Access Compliance Report Public Rights-of-Way (Pedestrian Signals)

Main Street: **ANTONIO_PKWY** Cross Street: **N/A** Location: **N**

ADA ID: **SGAT220208123809** Signal Type: **One Push Button-APS** Overall Compliance: **No** Severity Scores: **BTN 1: 25** **BTN 2: N/A** **No BTN: N/A**

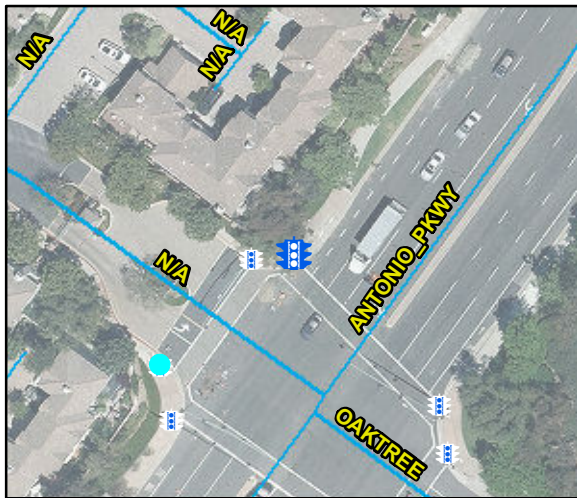
OC Std/PROW: **R404.2, R404.3**

Possible Solutions: Remove and Replace Clear Space.
